Arizona Department of Transportation

MEMORANDUM

To: All Users of the Construction Standard Drawings- C-Standards	**Date:** July 19, 2001
From: John L. Louis Assistant State Engineer Roadway Engineering Group	**Subject:** C-Standards Revisions

ELEVATION
BARRIER WITH CURB AND GUTTER

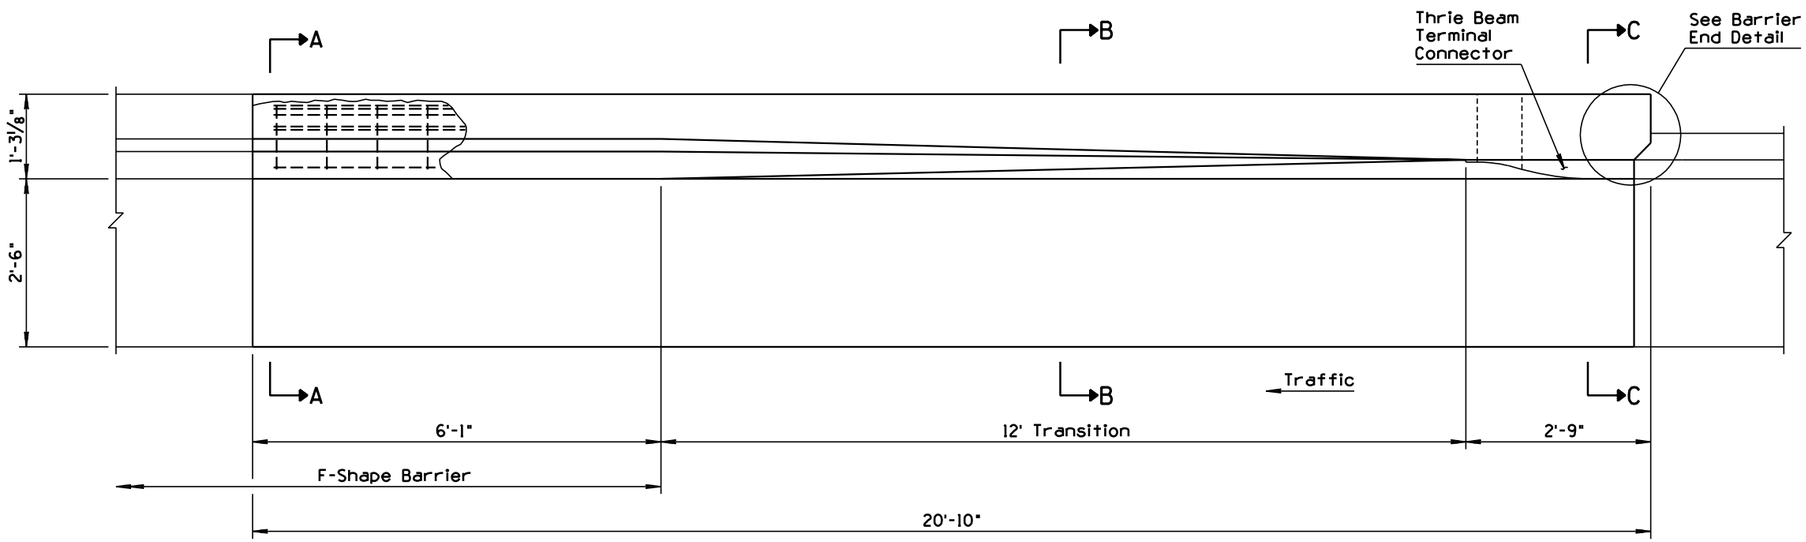
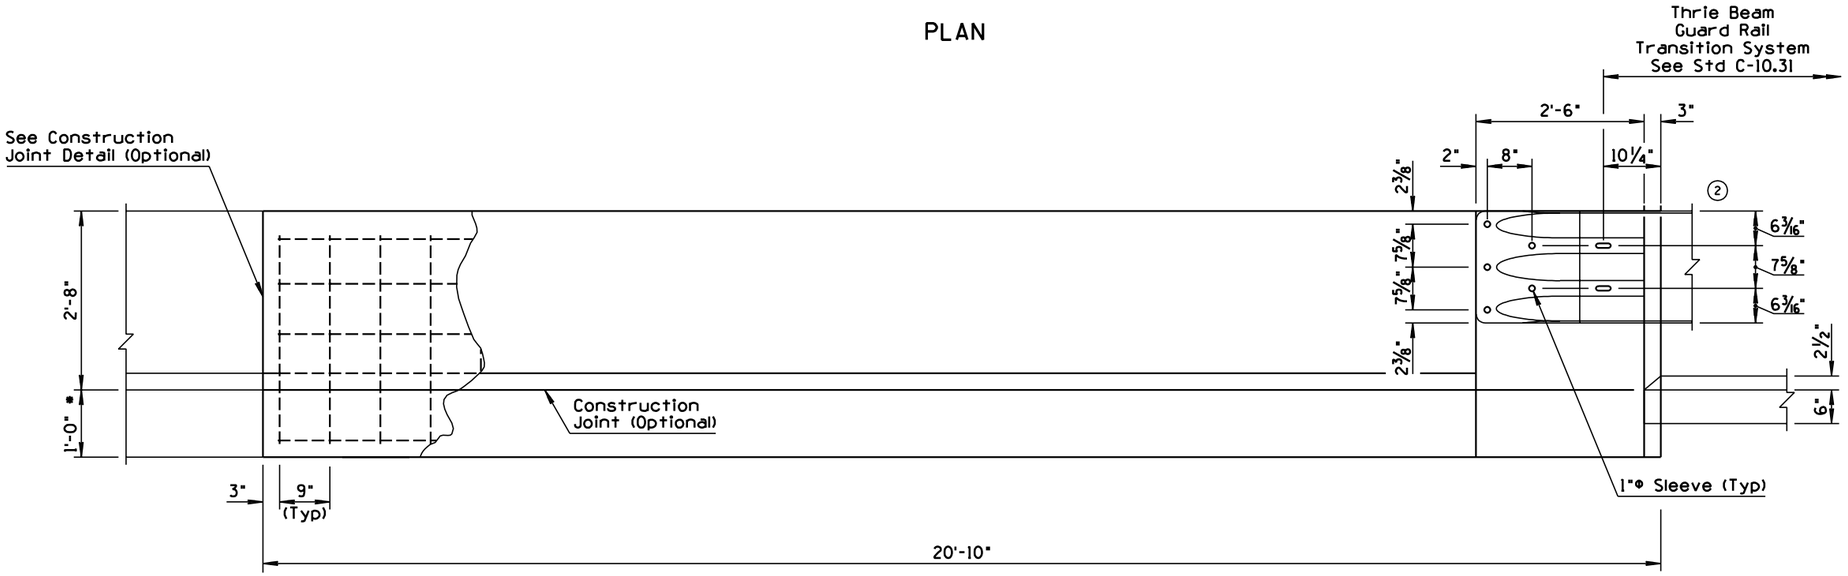
NO	DESCRIPTION OF REVISIONS	MADE BY	DATE
1	REVISED TO MEET NCHRP 350 REQUIREMENTS	JNP	8/99
2	RAISED THRIE BEAM 1"	RLF	7/01
3			
4

SECTION A-A

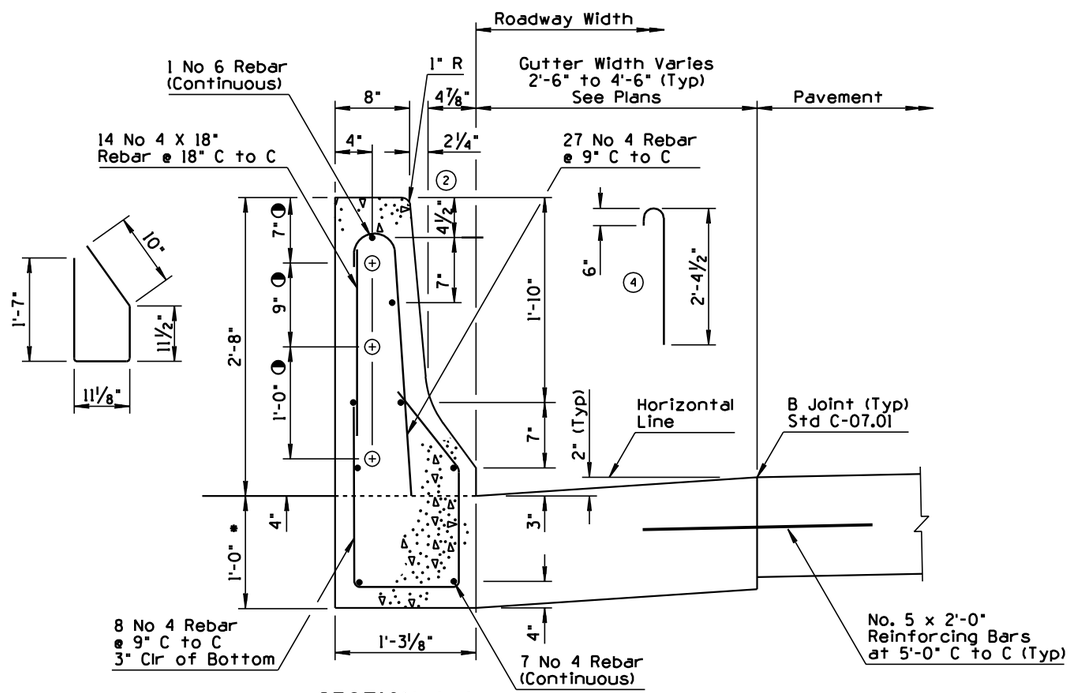
NO	DESCRIPTION OF REVISIONS	MADE BY	DATE
1	REVISED DRAWING & DIMENSIONS	JNP	4/00
2	RAISED THRIE BEAM 1" & REPOSITIONED TOP REBAR	RLF	7/01
3	REVISED FROM PIPE TO SLEEVE	RLF	7/01
4	REVISED REBAR DIMENSIONS	RLF	7/01

BARRIER WITH CURB AND GUTTER

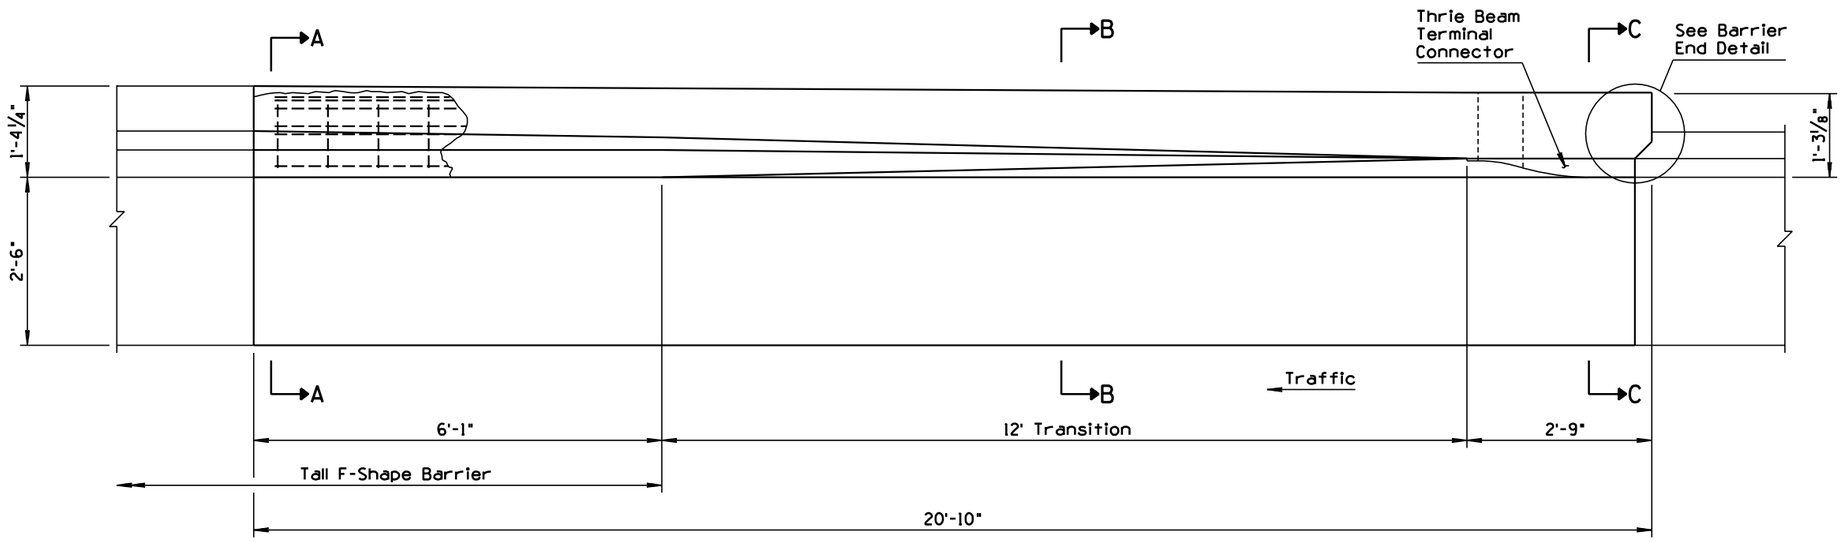
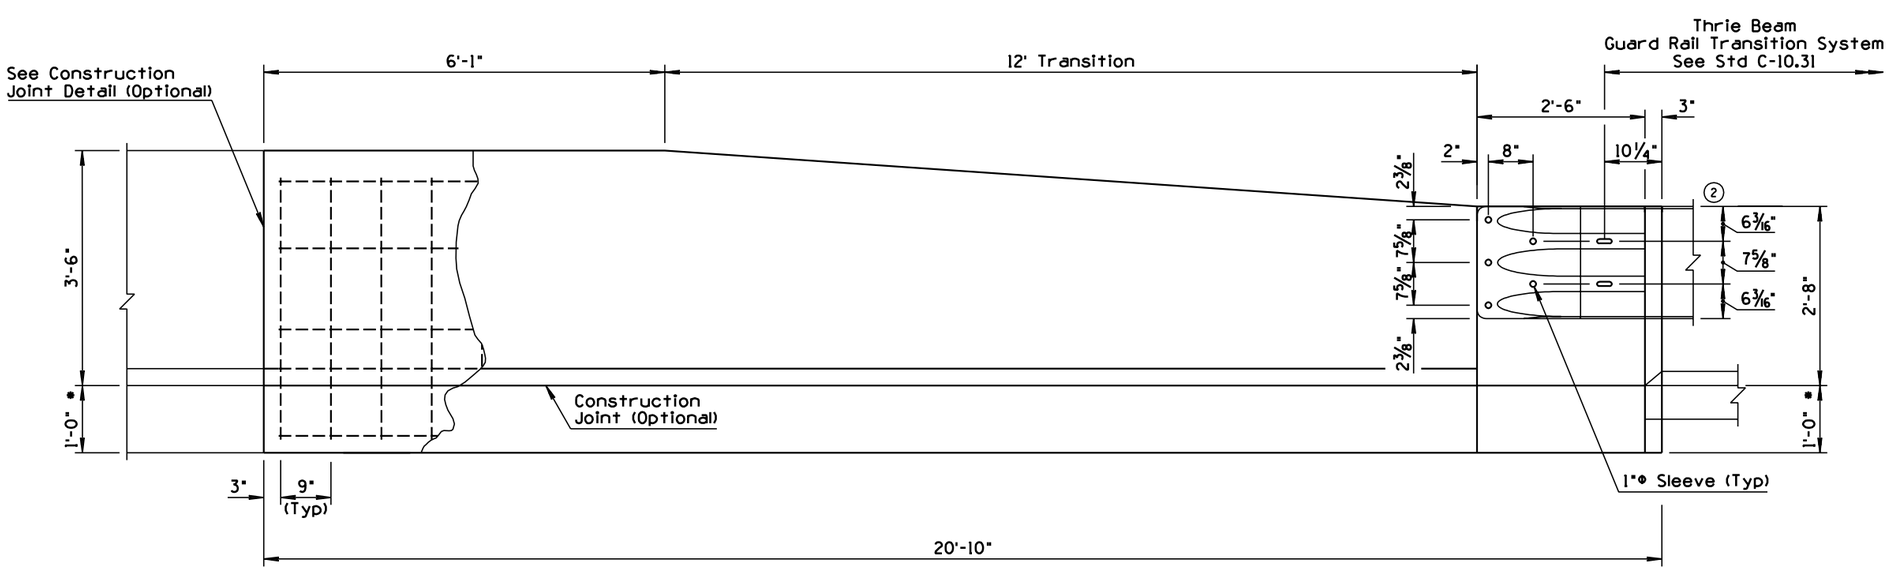
NO	DESCRIPTION OF REVISIONS	MADE BY	DATE
1	NEW STANDARD DEVELOPED	JNP	8/99
2	RAISED THRIE BEAM 1"	RLF	7/01
3			
4

SECTION A-A

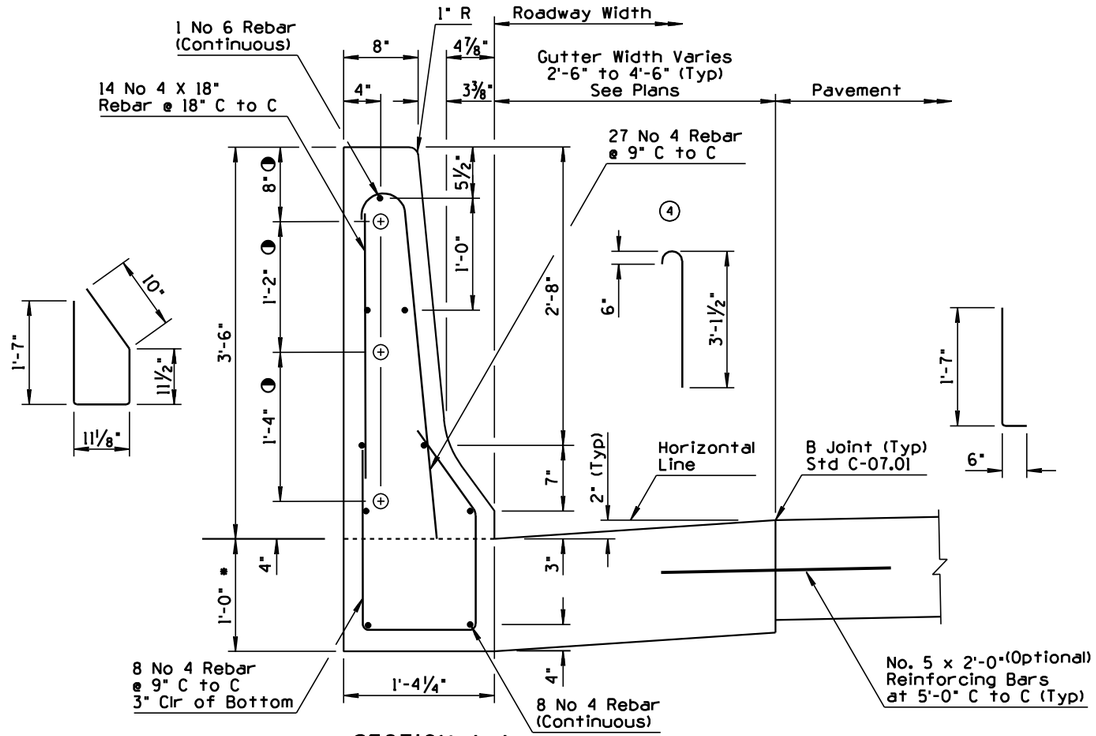
NO	DESCRIPTION OF REVISIONS	MADE BY	DATE
1	REVISED DRAWING & DIMENSIONS	JNP	4/00
2	RAISED THRIE BEAM 1" & RAISED TOP REBAR	RLF	7/01
3	REVISED FROM PIPE TO SLEEVE	RLF	7/01
4	REVISED REBAR DIMENSIONS	RLF	7/01

PLAN

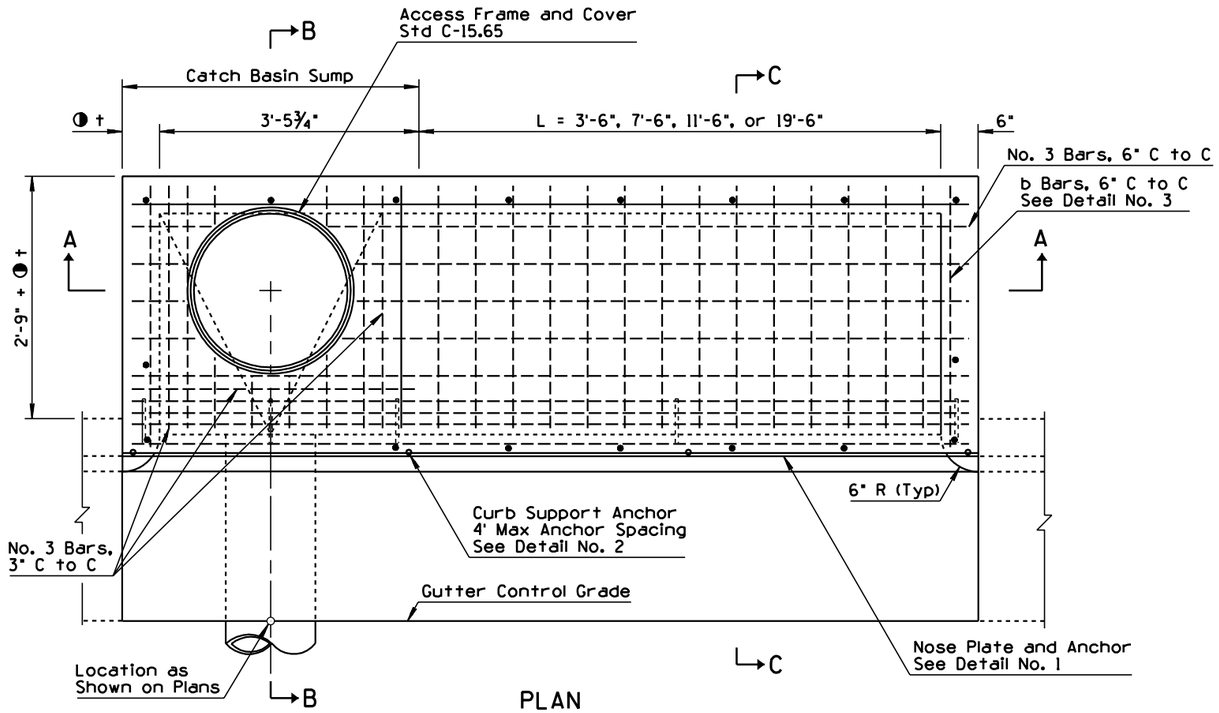
NO	DESCRIPTION OF REVISIONS	MADE BY	DATE
1	REVISED NOTE # 11	RLF	7/01
2			
3			
4

PLAN

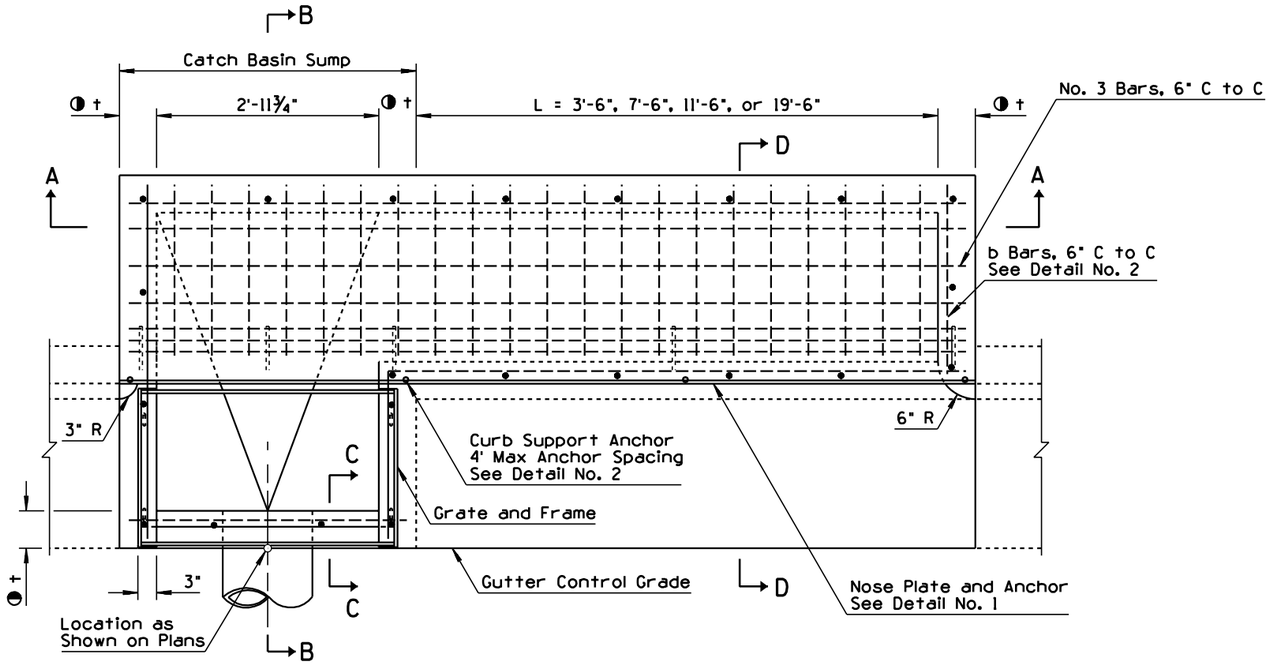
NO	DESCRIPTION OF REVISIONS	MADE BY	DATE
1	REVISED NOTE # 11	RLF	7/01
2			
3			
4
